# CUI DEVICES

## Product Change Notice (PCN)

**PCN Number:** PCN-0370542-01

**CMT-8504-100-SMT-TR**

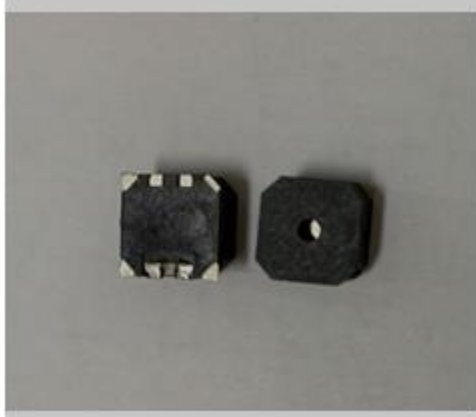
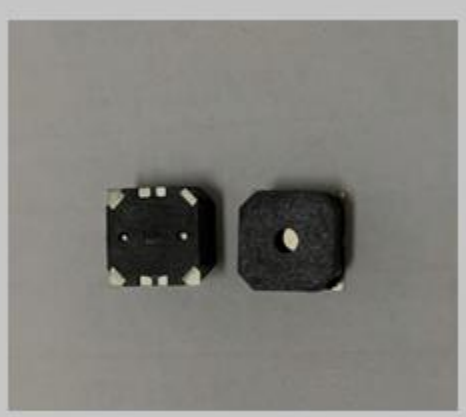
**Improving the structure by changing the bottom to integrated with injection molding, and the connection parts being put inside. The item will now be done by machine to increase the capacity of production.**

**The only change is the injection Molding. This does not change any of the Characteristics of the product.**
